CARDONE ProTech

Water Intrusion Causes Many Wiper Motor Problems

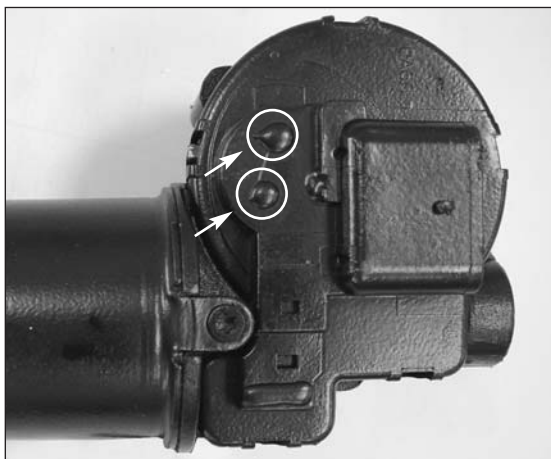
Wiper motors with and without integrated electronic pulse board not working properly or at all.

Wiper motor and/or electronic components may have failed due to water intrusion.

To prevent water intrusion, our replacement units are re-engineered to overcome original design flaws. Vent holes that allow water entry are blocked, therefore protecting the motor & its electronic components.

To protect the replacement wiper motor and pulse board, be sure water does not drain on wiper motor assembly. Remove any debris that might block or restrict the flow of drain water to the left or right fender well areas. Be sure to also check for proper operation of control switch and associated wiring.
